REMARKS/ARGUMENTS

Appl. No. 10/630,249
Amdt. dated February 9, 2005
Reply to Office Action of August 10, 2004

Amendments to the Drawings:

FIG. 2B

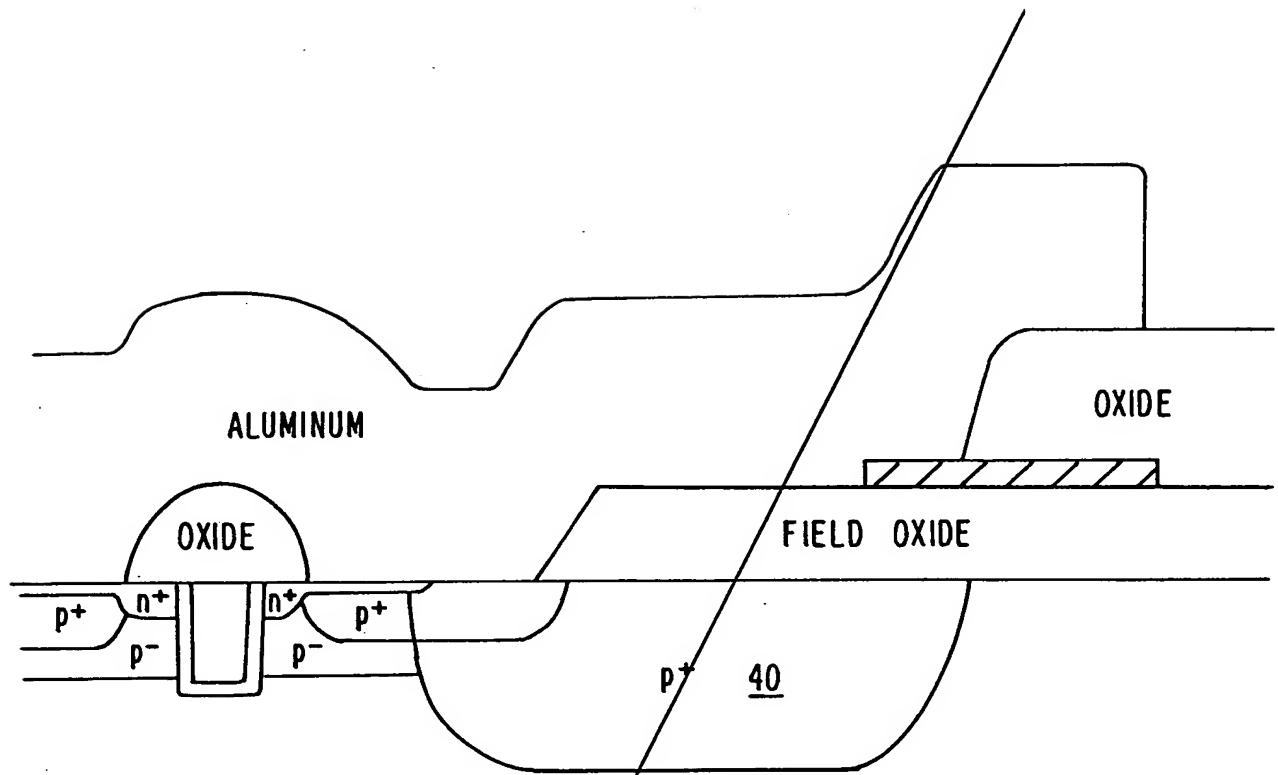
The drawings have been objected to under 37 C.F.R. 1.83(a) for failing to show every feature of the invention recited in the claims. Specifically, the objection has required Applicants to show the termination trench structure or cancel corresponding claims. Figure 2B has been added to illustrate the claimed trench termination structure that was described in the specification as originally filed, for example, at page 7, lines 32 *et seq.* The specification has also been amended to reflect the addition of Figure 2B. Applicants submit that no new matter is introduced by the amendments to the drawings and the detailed description. Applicants point out that support for this amendment can be found not only in the detailed description section of the application as originally filed, but also in USPN 5,430,324, which was incorporated by reference at page 8, lines 5-6, of the application for the specific purpose of further elaborating on the trench termination structure. Applicants believe this amendment addresses the objection to the drawings and respectfully request withdrawal of the objection.

The attached sheet of drawings including Figures 2A and 2B replaces the original sheet including Figure 2. A marked-up sheet indicating these changes is also attached.
